McCULLOCH CORPORATION
SERVICE BULLETIN

1560

MODEL: Mini-Mac 30, 35

SUBJECT: NEW THROTTLE ROD CLIP

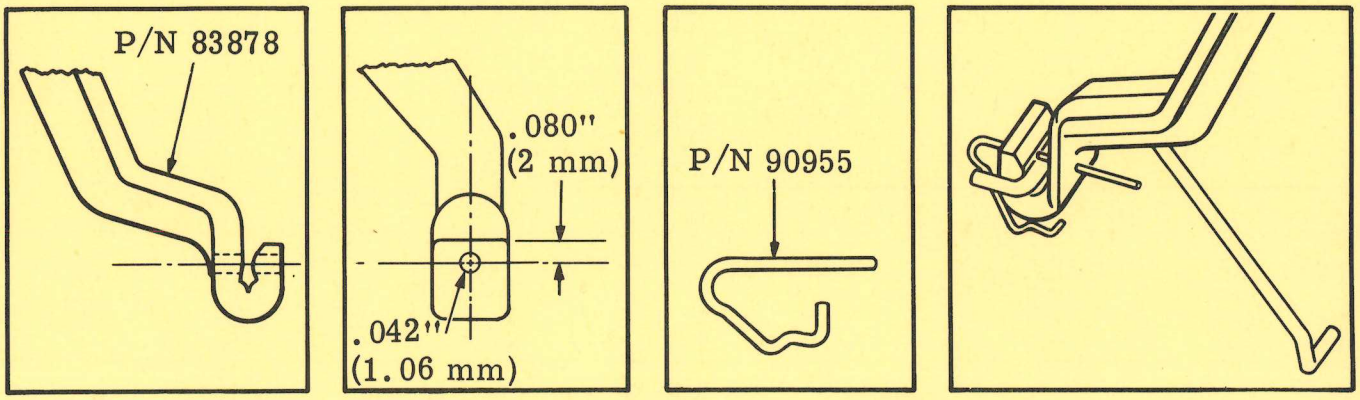
A small Clip, P/N 90955, is now being installed in the throttle Trigger, P/N 83878, to prevent the possibility of throttle rod from slipping out of the trigger hook. The trigger is drilled to accept the clip.

2. Holding the clip with a pair of needle nose pliers, push the straight end of the clip into the drilled hole until the curved end of the clip slides under the curve at the bottom of the trigger hook.

2. Drill a .042 inch hole (1.06 mm) through both walls of the trigger hook as illustrated. (Drill the hole approximately .080 inch (2 mm) below the outer lip).
